Access Compliance Report

Public Rights-of-Way

Intersection ID: 9962	Main Street: LITTLE ROCK RD	Cross Street: TUCKASEEGEE_RD	Location: NW
ADA ID: D3D3B6B5DA8A	Ramp Type: BlendTrans1	Initial Pass/Fail: Fail	Overall Compliance: No
		Severity Score: 10

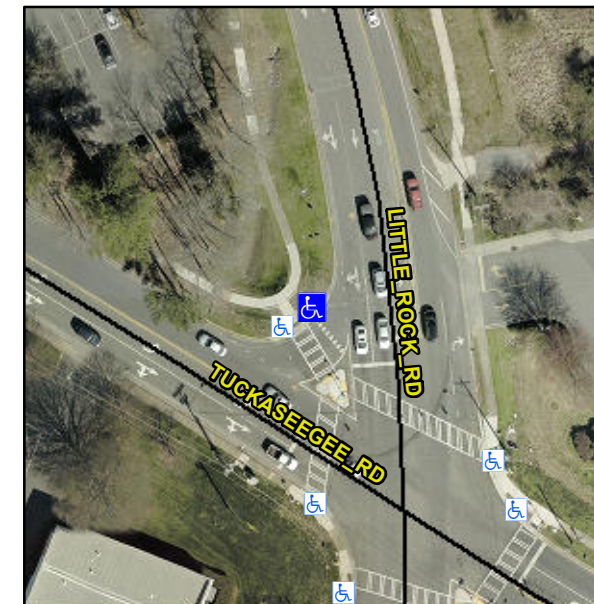
Not Found, R304.5.1, R304.5.3

Compliance	Description	Data	Compliance	Description	Data
N/A	Ramp Length (in)	60.0	Yes	BlendTrans Slope (%)	2.7
No	Ramp Width (in)	47.0	No	BlendTrans XSlope (%)	3.4
N/A	Flare Type LT	N/A	N/A	Flare Type RT	N/A
N/A	Flare Slope LT (%)	N/A	N/A	Flare Slope RT (%)	N/A
N/A	Flare Traversable LT?	N/A	N/A	Flare Traversable RT?	N/A
N/A	Landing Length (in)	N/A	N/A	DWS Provided?	N/A
N/A	Landing Width (in)	N/A	N/A	DWS Contrast?	N/A
N/A	Landing Slope (%)	N/A	N/A	DWS Length (in)	N/A
N/A	Landing X Slope (%)	N/A	N/A	DWS Full Width?	N/A
N/A	Landing Curb? (Y/N)	N/A	N/A	DWS Offset (in)	N/A
N/A	Shared Landing?	N/A			
N/A	Gutter Ponding?	N/A	N/A	Gutter Slope (%)	N/A
N/A	Gutter Lip Ht (in)	N/A	N/A	Gutter X Slope (%)	N/A
N/A	Painted X Walk1?	No	N/A	Painted X Walk2?	N/A
	X Walk 1 Direction	To E		X Walk 2 Direction	N/A
	X Walk 1 Width (in)	N/A		X Walk 2 Width (in)	N/A
	X Walk 1 Slope (%)	1.3		X Walk 2 Slope (%)	N/A
	X Walk 1 X Slope (%)	3.2		X Walk 2 X Slope (%)	N/A

N/A	Ramp inside XWalk1?	N/A	N/A	Ramp inside XWalk2?	N/A
	Road Slope (%)	3.2		Clear Space?	N/A
	Road X Slope (%)	1.3	N/A	Clear Space to XWalk (in)	N/A
N/A	Any Obstructions?	N/A	N/A	Storm Grate/Utility Hazard?	N/A
	Obstruction Type			Storm Grate/Utility Type	
		N/A			N/A
			Yes	Surface Condition? (G/P)	Good
			No	Curb Slope (%)	14.4

Remove & Replace Curb Ramp With Two New Directional Ramps or Equivalent.
